**Addendum # 005**

**TENDER NUMBER: 619-CP2003**

**Renovations and Atrium Project**

**Our Lady of Fatima Catholic School**

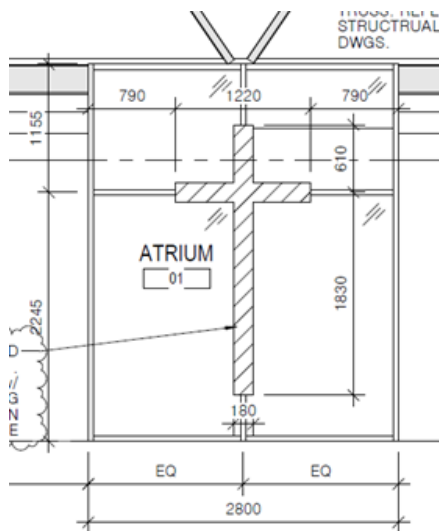
Q5: Please confirm what type of glass is in each door/frame. The door schedule only notes yes for glass but does not clarify what type of glass.

A5: Please refer to Drawings and Specifications Issued as part of this addendum. This question is addressed.

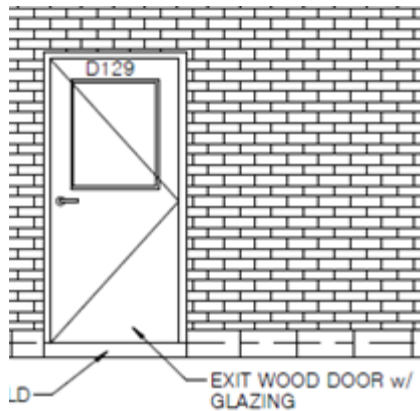
- Q13: Is the frame below an aluminum or hollow metal frame? What type of glass? There is no tag on it, please clarify.

- A13: Please refer to Drawings and Specifications Issued as part of this addendum. Clarifications have been addressed.

**1 ENLARGED GYM & ENTRY FLOOR PLAN**  
 SCALE 1 : 100

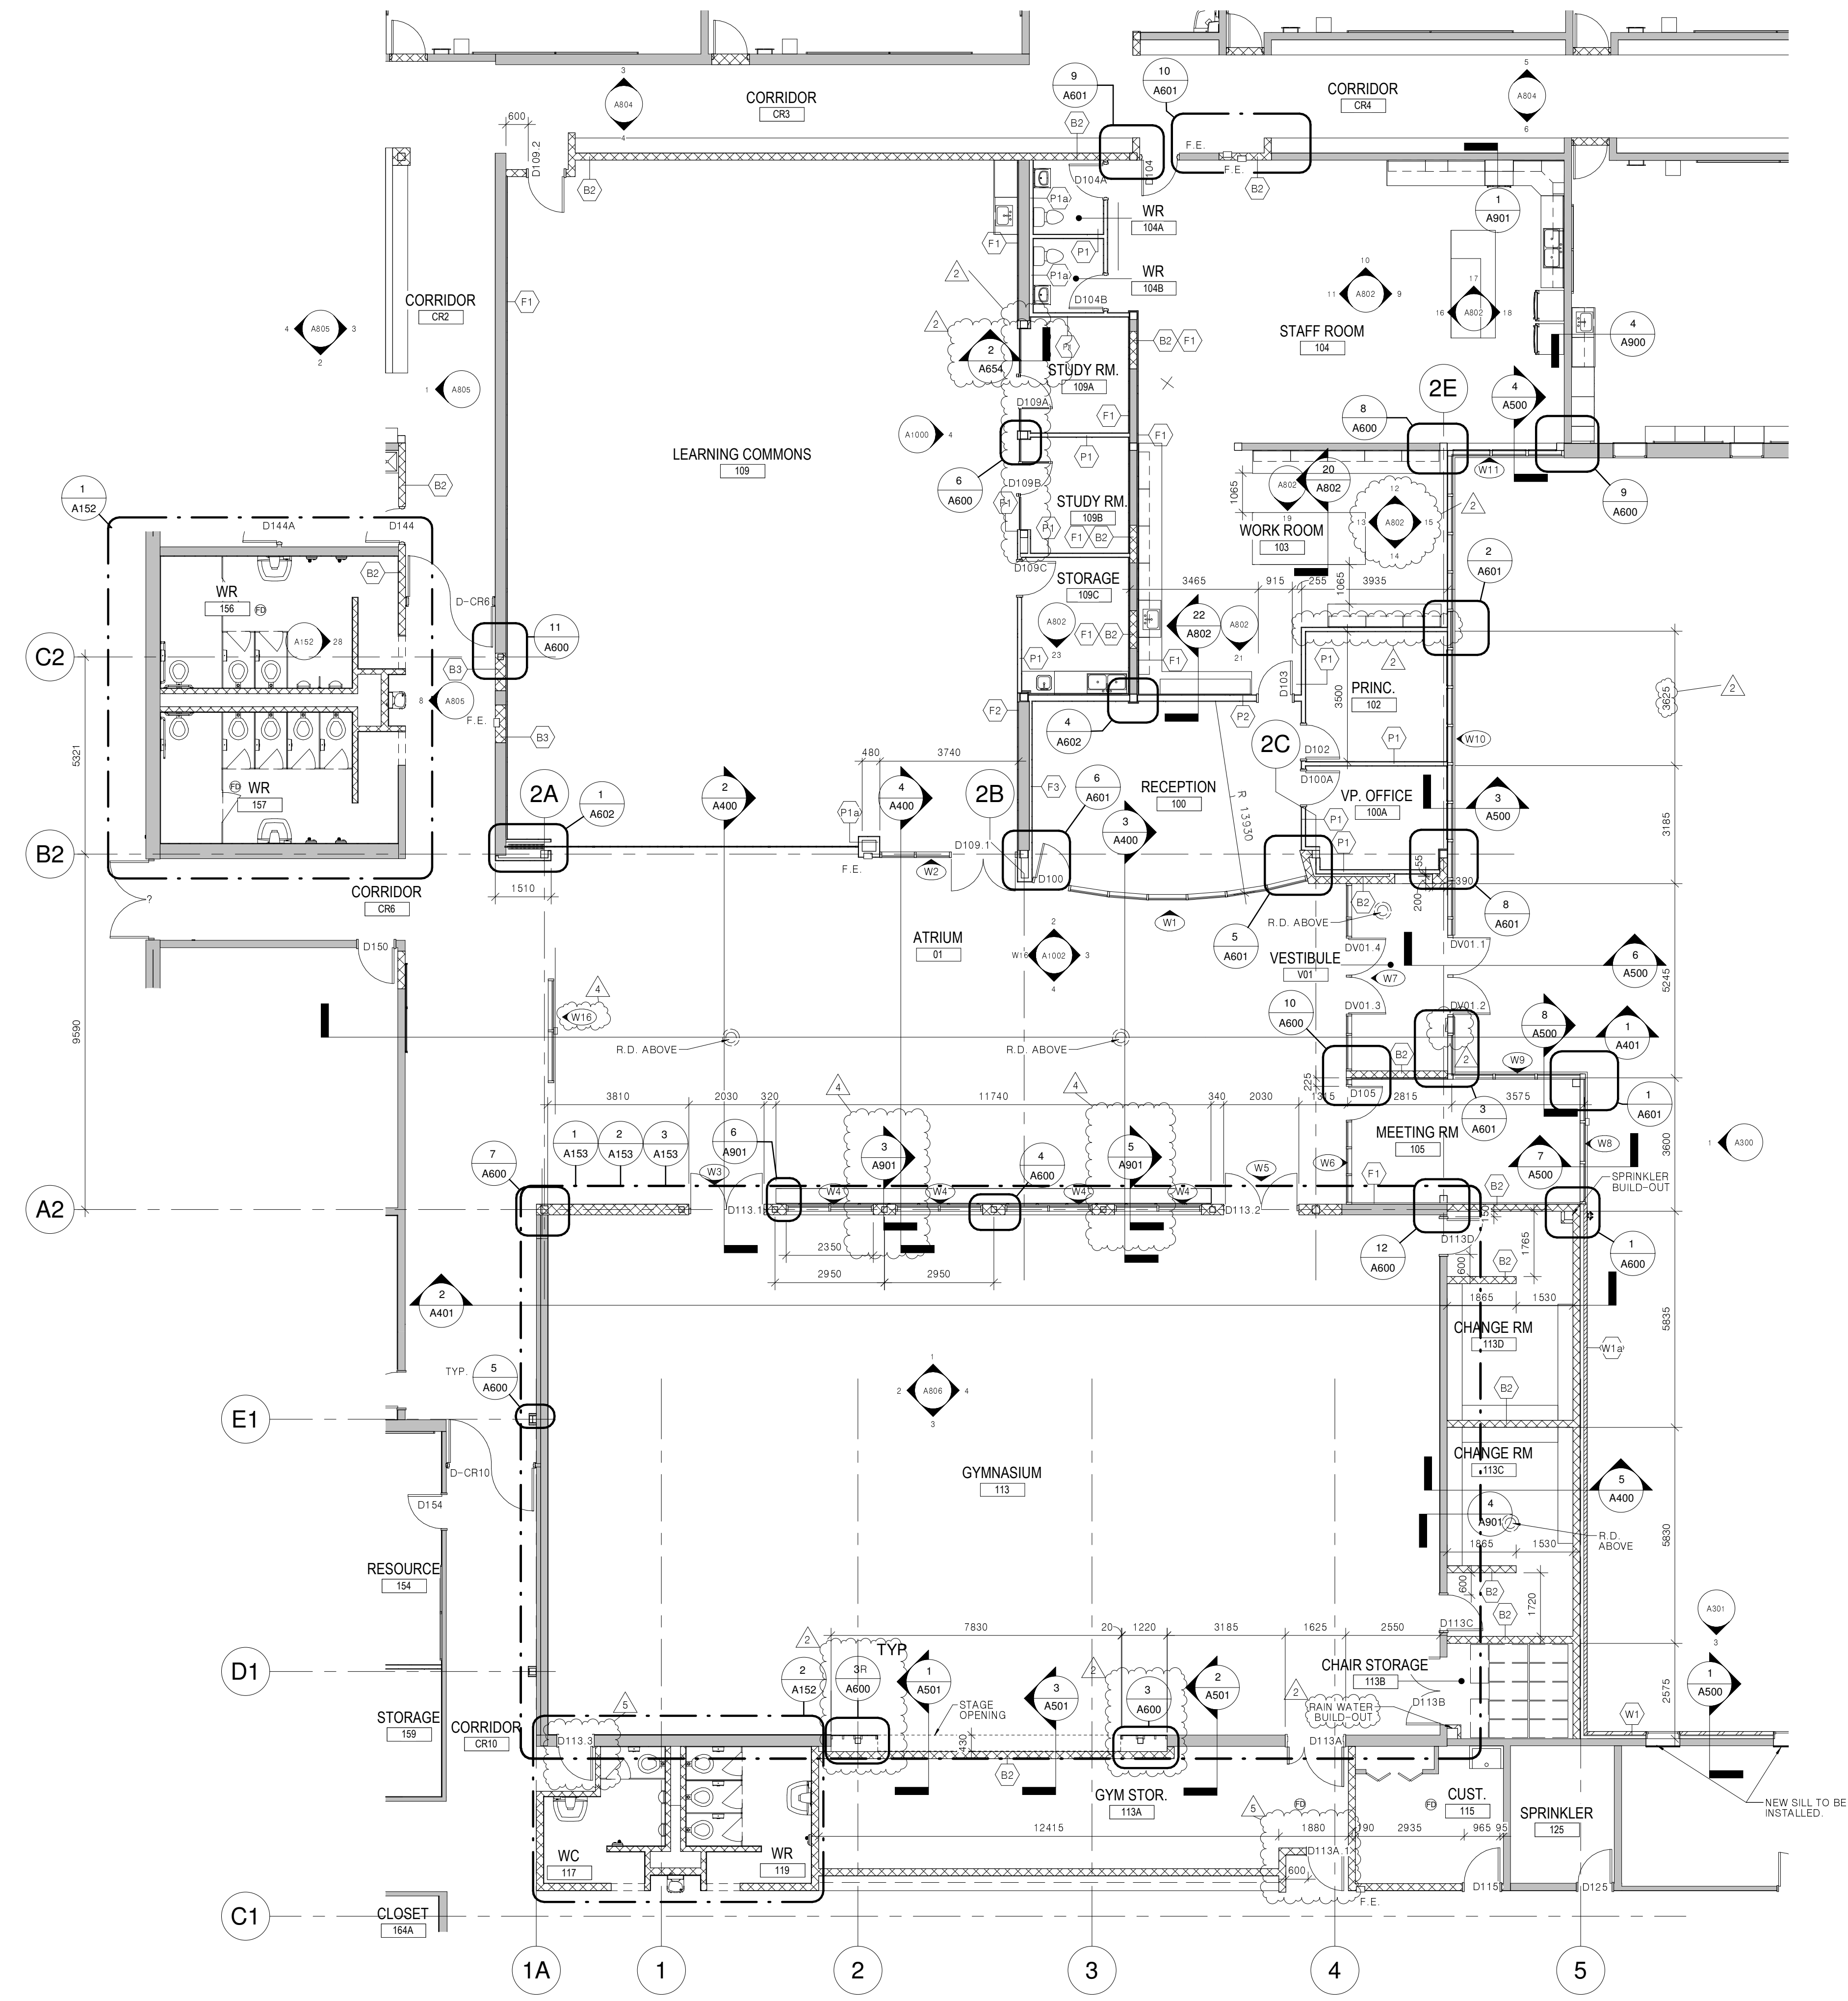
Q7: Where are door types D125.k-D125.n on the floor plan? Are two of these the learning commons doors or what are their door numbers?

A7: Refer to Addendum # 004, reissued drawing A151. D125 L and 125N remain as all glass doors. Refer to Elevation 4/A1000 and specifications. Doors 125K and 125M are deleted. Please refer to Drawings and Specifications Issued as part of this addendum.
